Project Deliverable F: Prototype I and Customer Feedback

Group 10

March 7, 2021

University of Ottawa

This drawing shows an exploded view of our sensor system. It also shows our wire management and how the wires will be clipped to make sure they won't become loose and hang.

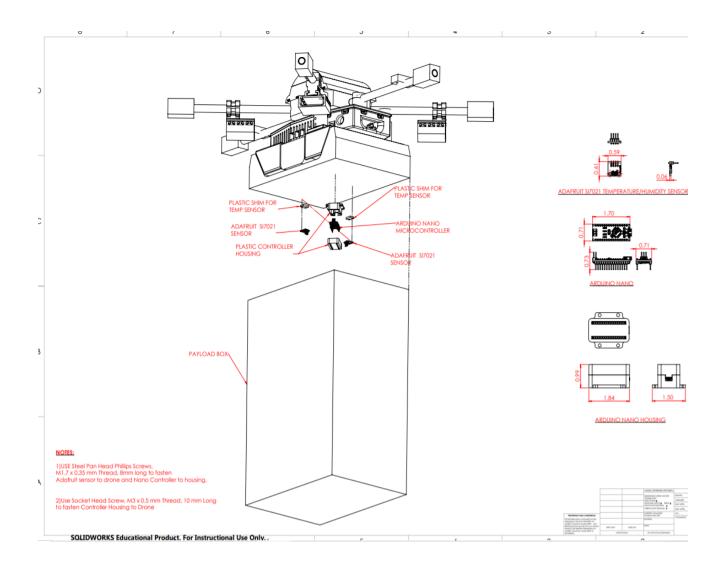
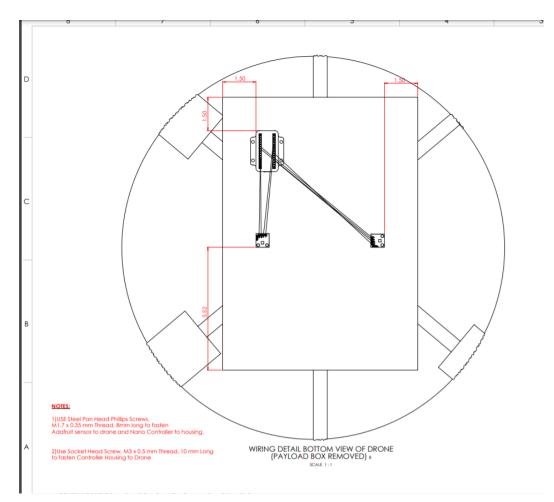
Customer	Feedback	Score
Supathira's Parent	"The prototype looks really nice and sleek." The compact size of the prototype also does not take away from the drone's overall aesthetic either."	9/10
Benjamin's Parent	"The prototype looks great, the concept is clear, and the wiring is good. However, how the information gets to the drone computer is still rudimentary."	7/10
Evan's Parent	"The prototype looks nice but enclosing it in a case that is black would improve the aesthetic, it would make the prototype look more elegant."	8/10
Alison's Parent	"The prototype looks professional due to wires and parts being all over the place and a mess. The clean look of the prototype makes the aesthetic of the prototype surreal."	10/10
Gabriel's Parent	"The prototype seems clean but would look better if the sensors were put together or in a position where wires are not overlapping ."	7/10

On the other hand, this feedback has also allowed us to see that customers are looking for aesthetic appeal. We did not expect this criteria to have such a great impact on our clients perspectives of the product. As such, we are looking to add a better look to our design by putting our arduino and sensor in black-colored boxes and hiding the bunch of wires as much as possible.

Another feature that adds to the aesthetics of the prototype is the hardware enclosure. Enclosing the prototype in a case so that the electronic parts are not visible will increase the overall aesthetics of the module. Since the drone will be visible to JAMZ's customers, it is important that the temperature sensor system is consistent with the drone's aesthetic.
